**FINAL ENVIRONMENTAL IMPACT REPORT
GRAYSON REPOWERING PROJECT**

RESPONSE TO COMMENTS
March 1, 2018

9.1.1 Topical Responses

Figure 9-1 Compare Glendale's Renewable Energy Portfolios with Burbank, Pasadena, LADWP, and California as a Whole

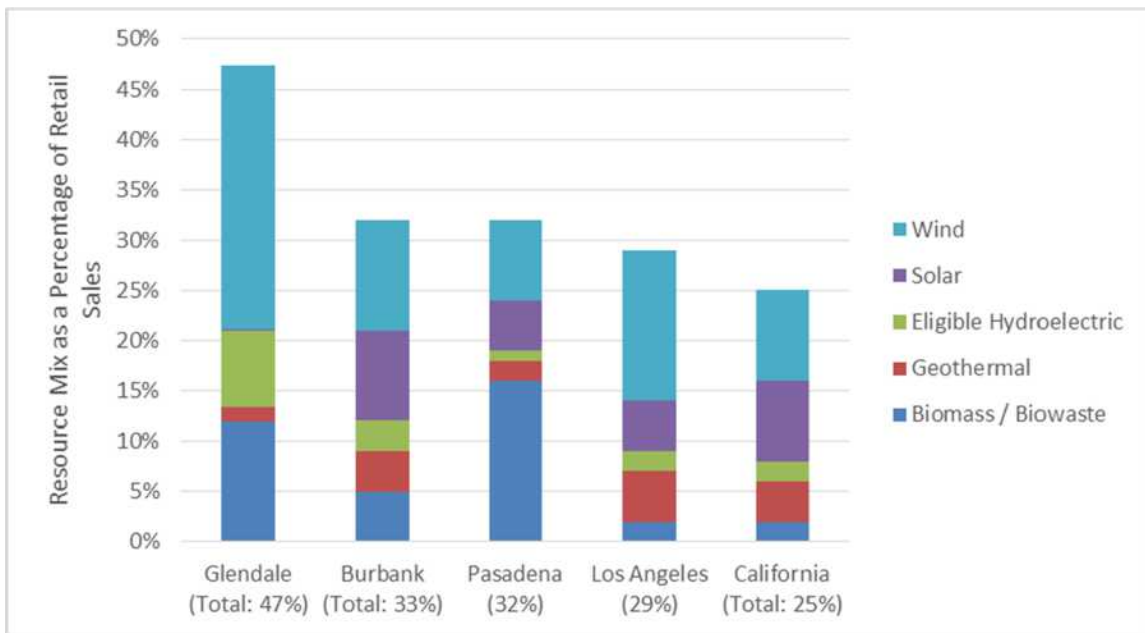
Comments were received stating that Glendale should not put “all of its eggs in one basket” by single-mindedly pursuing the construction of a large, gas-fired plant when alternative, green technologies are available and are continuing to develop. Commenters state that Glendale should instead consider an integrated solution that includes solar generation, storage, demand management and energy efficiency measures.

Figure 9-1 and 9-2, below, compare Glendale's renewable energy and carbon-free portfolios with Burbank, Pasadena, LADWP, and California as a whole.

Figure 9-1 reflects the contents of each city's respective 2016 Power Content Label, which are the most recent ones available/certified (2017's numbers will likely not be certified until this fall).
